Truro Loops Phase 1 Newham Road

Road Safety Audit – Stage 1 & 2

Document Ref: T/RSA722/R3

Photo 3

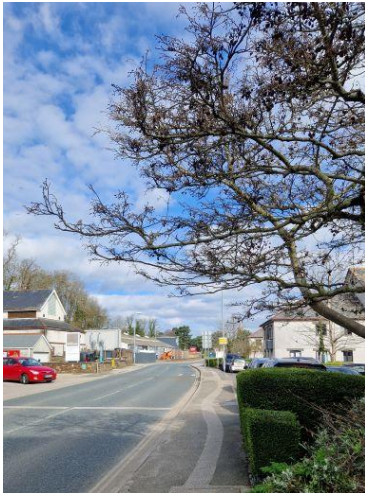
The appears to be a length of shared-use facility outside Morlaix House, where the width reduces to 2.1 metres. As there is vegetation abutting the edge of the existing footway (Photo 3), this would reduce the usable width of the facility for cyclists down to 1.6 metres, as cyclists would not be able to ride along the rear edge of it. Although forward visibility is good, and the narrow width is over a fairly short distance of around 35 metres, this is too narrow for shared-use with pedestrians and could result in a collision between both.

There are low-hanging tree branches over the existing footway, from a tree located outside of 'Bluebird Care' at Morlaix House (Photo 3). Cyclists riding on the proposed shared-use facility following its conversion, may be at risk of a branch getting caught in their cycle helmet and pulling them from their bicycle and causing them to fall, or a branch could strike them in the face, resulting in injury.

Widen the shared-use facility across the frontage of Morlaix House to provide a minimum of 2.5 metres of shared-use width. For example, the proposed carriageway width here is 6.5 metres therefore, the shared-use facility could be widened and additional 300 - 400mm.

Remove low-hanging branches
